An instrumented screwpile load test and connected pile-group load-settlement behavior.

**Discussion of a paper by VanImpe, P.O.,
VanImpe, W.F., and Seminck, L., 2013.
Journal of Geo-Engineering Sciences, IOS Press, 1(1) 13-36**

Discussion Paper

Bengt H. Fellenius*

Fig. 1. Pile ultimate shaft resistance — Measured and as calculated by 5 CPT methods. And soil profile with CPR qc-diagram.

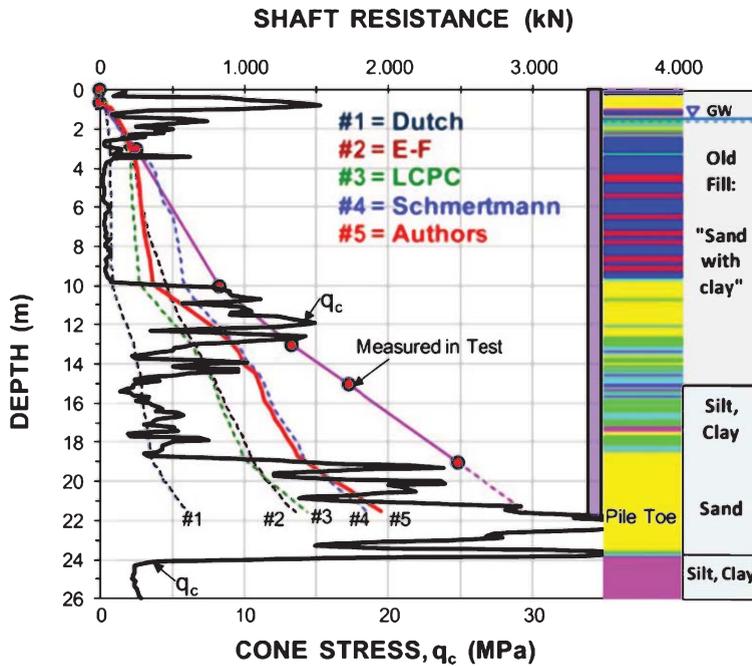
Figure 1 presents the CPT cone-stress diagram together with the authors' CPT-calculated shaft resistance distribution and the shaft resistance distributions calculated using four additional methods. The figure is supplemented with the distribution of shaft resistance measured in the static loading test at the maximum applied load and the interpreted soil profile. The CPT methods suggest that the ultimate shaft resistance of the test pile should be about 1,500 kN through about 2,000 kN.

Fig. 2. Pile toe resistance — Maximum in test and “ultimate” as calculated by five CPT methods.

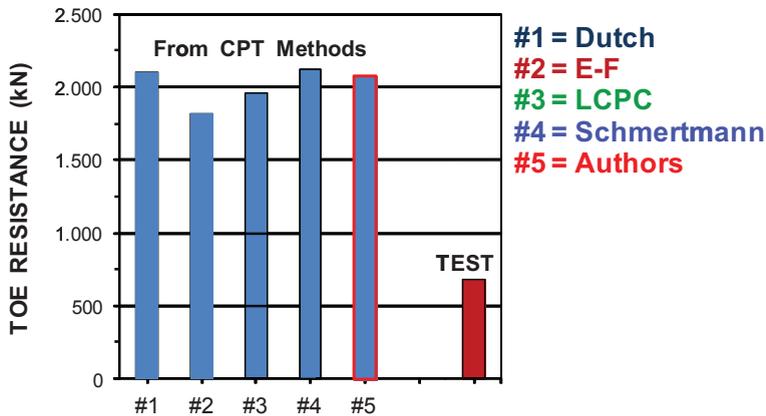
Figure 2 shows the toe resistances calculated using the same methods as determined at the maximum load applied to the pile head in the static loading test. Obviously, the CPT methods have all vastly overestimated the maximum toe resistance developed in the static loading test. The pile toe is 2.5 m, about 5 pile diameters, above the clay layer, which ordinarily should be enough to prevent a softening of the toe response due to the presence of the clay. Therefore, a question is if the depth to the clay layer varies appreciable across the site, the distance to the clay layer might be smaller at the test pile location. However, the authors' Fig. 14 indicates that the variation of the depth to

Fig. 3. Load movement curves for head, shaft, toe, and compression.

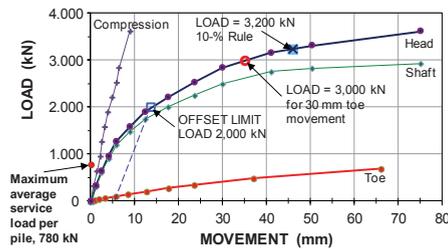
Figure 3 shows the load-movement curves measured in the static loading test for the pile head, the pile shaft, the pile toe, and the pile compression. The pile toe curve is plotted using the toe load extrapolated from the extensometer measurements. (The authors instead plotted the pile-head load versus the pile-toe movement.)

The measured shaft resistance load-movement curve does not indicate a clear value of ultimate shaft resistance. It can be estimated to range between 2,750 kN at a pile head movement of 40 mm through 2,930 kN at about 70 mm movement. Thus, the evaluation of the extensometer records indicates that the ultimate shaft resistance determined from the static test is about one-and-a-half times larger than that calculated by the CPT methods.

It is important to notice that the pile toe load-movement response is by a gently rising convex curve that does not have the slightest tendency toward a value one could reasonably define as the ultimate toe resistance. This is no surprise, it is what all properly instrumented and analyzed tests will show. Simply, ultimate toe resistance does not exist [4]. It is bewildering that the concept of ultimate toe resistance and a plastic response of the pile toe is still almost universally believed to exist—and applied to piled foundation design.

Fig. 4. Load and resistance distributions as measured and as adjusted for residual load with distribution of back-calculated beta-coefficients.

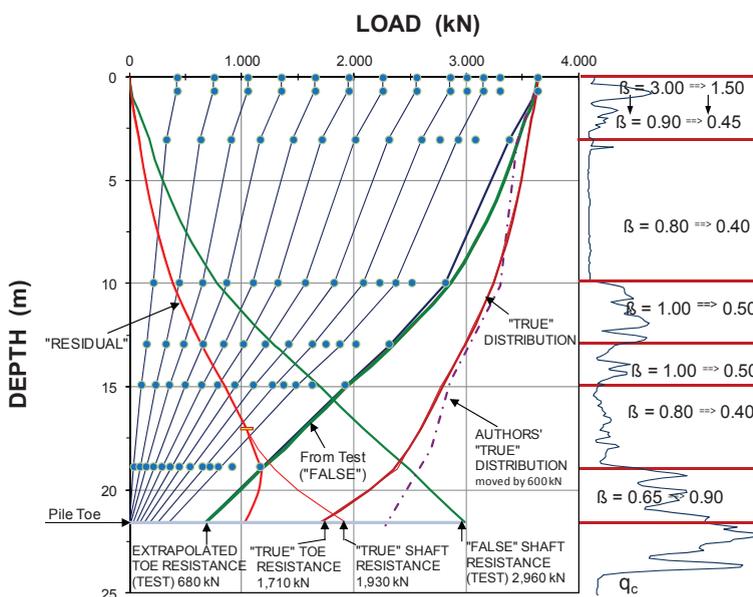
The authors suggest that the disagreement between shaft resistance calculated using the CPT-method and that found in the evaluation of the extensometer records of the test could be due to the presence of locked-in loads in the test pile, so-called residual load. They provide a load distribution corrected for residual load, which distribution is approximately equal to that produced by their CPT-method. The distribution, labeled AUTHORS’ “True” Distribution, is shown in Fig. 4 together with a more direct construction of the residual load per the principles published by Fellenius [5, 6]. The figure also includes the CPT cone stress superimposed on a column listing β -coefficients. The latter are the beta effective stress beta-coefficients back-calculated from, first, the measured load distribution (called “False”), and, then, the distribution corrected for residual load (called “True”). The three curves—the “Residual”, the “False” and the “True”—are linked, that is, any two of them determine the third. The three distributions indicate that the residual load resulted in fully mobilized negative skin friction down to about 17 m depth. Hereunder, a transition occurred toward partially mobilized positive shaft resistance.

It is not possible to tell from the records that residual load was actually present in the test pile at the start of the static loading test. It could be present and it could be as large as indicated by the authors’ “True” distribution. There is no definite indication either way. However, the β -coefficients back-calculated from the test records (the “False” distribution) are somewhat high overall and it is not logical that a β -coefficient of 0.80 would represent the shaft shear in the soft zone between the depths of 3 and 10 m. Neither is it logical that a β of 0.65 would represent the shaft shear in the very dense sand between the 10 through 22 m depth range. The coefficients back-calculated from the “True” distribution are, in contrast, logical in relation to each other and reasonable for the soil types.

The real “true” distribution probably lies somewhere in between the suggested “True” distribution shown in Fig. 4 and the distribution evaluated from the extensometer records. It is certainly disappointing that after all the effort

invested in the instrumentation, to find that the test results are unable to be more definite about the results. For example, the possibility of using shorter piles cannot be determined. Still, by simply performing an uplift test after the compression test, which would have been a relatively easy and low-cost addition to the testing programme, the issue would have been resolved. Not only would combining push and pull tests have provided the true ultimate shaft resistance (because the toe resistance would not be involved in the test), the residual load (which would have acted also on the uplift test) would have “worked the other way” and the analysis of the records from the two instrumented tests together would have determined the amount of residual load and its distribution.

Fig. 5. Observed deformations for Tanks 1 and 2 at maximum load and Tank 1 after unloading. The North direction is assumed vertical.

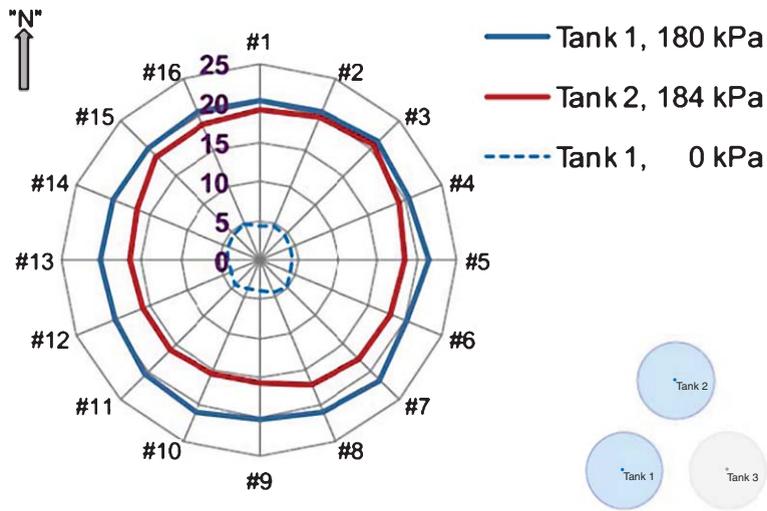
The authors mention that the interaction of unloading Tank 1 when loading Tank 2 affected Tank 2 resulted in a “tilt” of Tank 2 away from Tank 1. The term “tilt” for the differences in the observed deformation for Tank 2 is misleading, however. The tanks did not tilt. The reason for the difference in observed records is that no observations were taken of the Tank 2 perimeter benchmarks during the hydrotesting of Tank 1 (for reasons of

ongoing construction, I understand). This is clear in Fig. 5, showing a radial diagram for the maximum measured deformations along the Tanks 1 and 2 perimeters.

The measurements show that the deformations along the north-east portion of the tanks are very similar. However, in the south-west portion, the deformations on Tank 2 are affected from the outset by the fact that the stress induced from Tank 1 underneath Tank 2 was being reduced due to the fact that Tank 1 was simultaneously emptied of water. Similarly, the 0 kPa stress indicated for Tank 1 does not mean that the soil below the pile toe level is unstressed by tank load; it is stressed by the load applied to Tank 2 spreading over to the area below Tank 1. The dashed curve in the center of the diagram shows the net measured deformation for Tank 1 indicating a slight “tilt” toward Tank 2 because of the stress spreading effect. After the unloading of Tank 2 with now both tanks at zero load, had the true zero conditions then been recorded, the measurements would have shown no such “tilt”.

Fig. 6. Observed deformations for Tanks 1 and 3 at maximum load and Tank 3 after unloading. The North direction is assumed vertical.

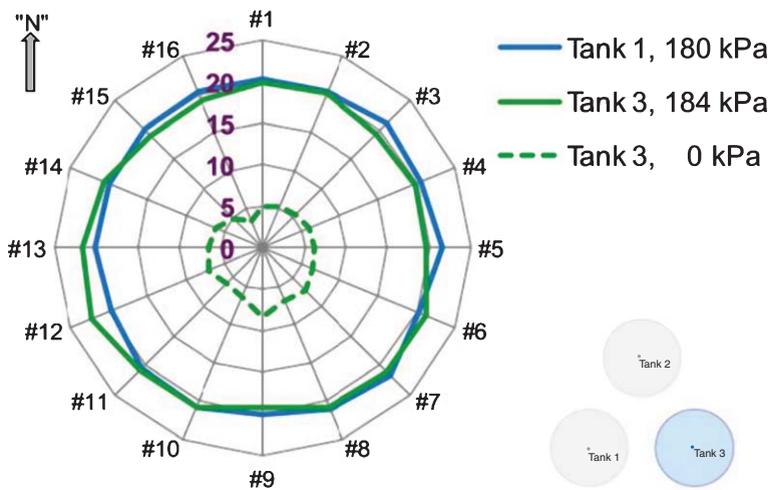
Tank 2 had been emptied before Tank 3 was hydrotested. Therefore, any influence of the stress from the hydrotesting of the adjacent tanks was gone before Tank 3 was hydrotested. Consequently, as indicated in Fig. 6, the

observed deformations for Tank 3 do not show any tendency of mutual interaction similar to the at shown in Fig. 5.

Fig. 7. Long-term settlement: immediate compression, residual compression, consolidation, settlement, and total settlement for a point at the center of the site.

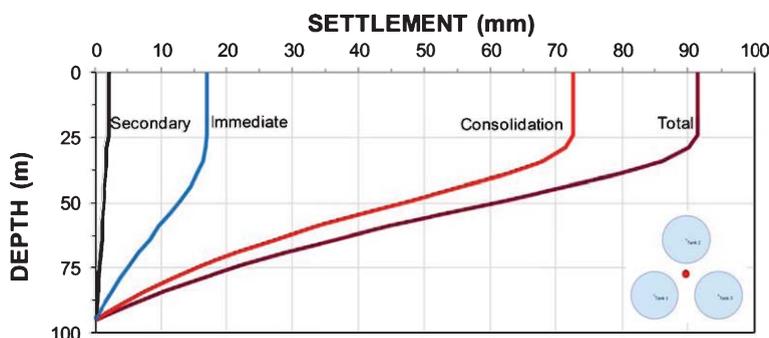
Figure 7 shows the long-term settlements versus depth below the center of the site: the immediate compression, residual compression, consolidation, settlement, and total settlement, as based on the mentioned soil compressibility (modulus number) and site specifics.

Fig. 8. Settlement versus time (years) as calculated for the Site Center and Tank 1 Point #5.

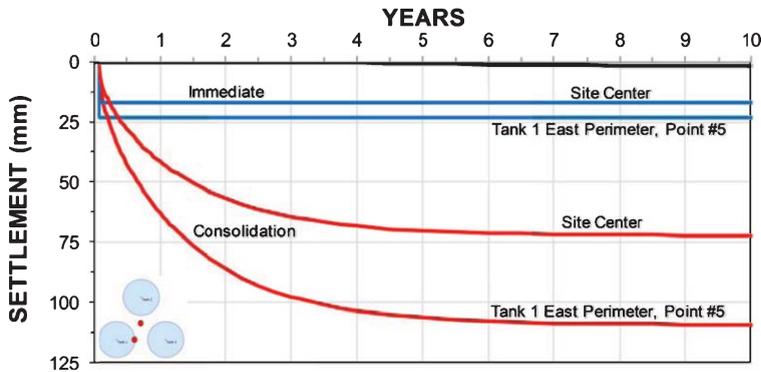
Figure 8 shows the development over time of the settlements for two points: the Site Center and Point #5 on the perimeter of Tank 1. Based on the assumed time for attaining 90-% degree of consolidation, only a marginal amount of settlement will develop after about 5 years. Of course, filling and emptying the tanks will result in ‘elastic’ compression and rebound, more or less immediate, of the piles and the soil.

Fig. 9. Settlement distributions below Tank 1 center line.

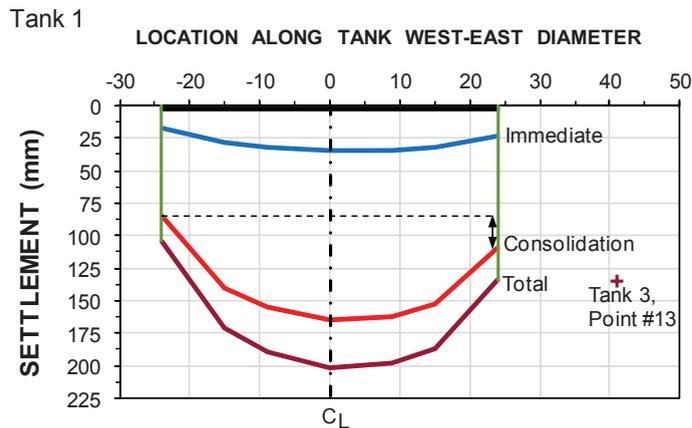
The calculations provide two important results: first, in the long-term the tanks will experience a small tilt due to the interaction of the loading, and second, the center of the tanks will settle considerably more than the perimeter. Figure 9 shows the calculated settlements for a diameter west to east of Tank 1 indicating that the tilt will be about 30 mm across the 65 m distance, i.e., about $1/20,000$, which is close to the authors estimated value of $1/12,000$. The settlement difference between the center of the tank and the perimeter will be about 100 mm, which might be of some concern for the tank base, should the predicted deformation actually develop.

The estimated—predicted—long-term deformations depend primarily on the relevance of the assumed compressibility of the clay, the modulus number of 80. I intended for this to be a realistic value, but one on the cautious side. The assumption of flexible foundation is conservative for the settlement difference between the tank center and perimeter; but not overly so. Regardless of the actual magnitude of the settlements, I expect that the center of the tanks will settle about twice as much as the perimeter.
